1RF-463 Javelina Facility

**OWL SWD OPERATING, LLC
[308339]**

Correspondence/Clarifications

Sump Plan & Details
Javelina Recycle Facility
 Ciudad Water Logistics
 Section 18, Township 26 South, Range 35 East
 Lea County New Mexico

LEAK DETECTION/SAMPLING SYSTEM DETAIL
Not to Scale

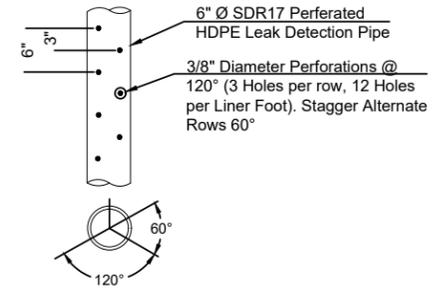
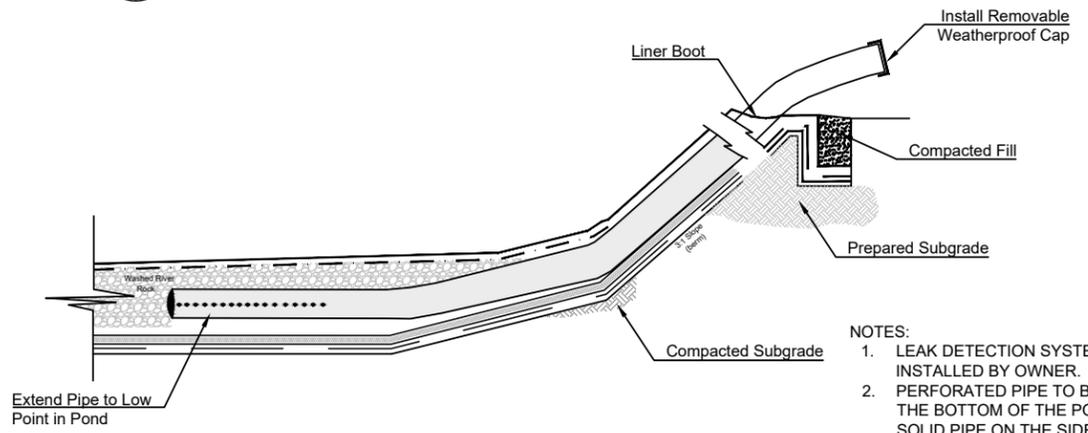
All,
Per 19.15.34.12.A.(7) **DESIGN AND CONSTRUCTION SPECIFICATIONS FOR A RECYCLING CONTAINMENT:**
(7) The operator of a recycling containment shall place a leak detection system between the upper and lower geomembrane liners that shall consist of 200-mil geonet or two feet of compacted soil with a saturated hydraulic conductivity of 1×10^{-5} cm/sec or greater to facilitate drainage. The leak detection system shall consist of a properly designed drainage and collection and removal system placed above the lower geomembrane liner in depressions and sloped to facilitate the earliest possible leak detection.

Question: In the proposed design, page 84, is the river washed rock layer two feet thick with the required saturated hydraulic conductivity? Could you provide a drawing that clarifies those details, please? Thanks,

Please see the attached Sheet 7. The table has been updated to accurately reflect the leak detection as 200-mil geonet. The washed river rock is only located in the sump as annual space for additional liquid to collect and be of sufficient quantity to pump up the leak detection pipe. Let me know if this clarification is sufficient.
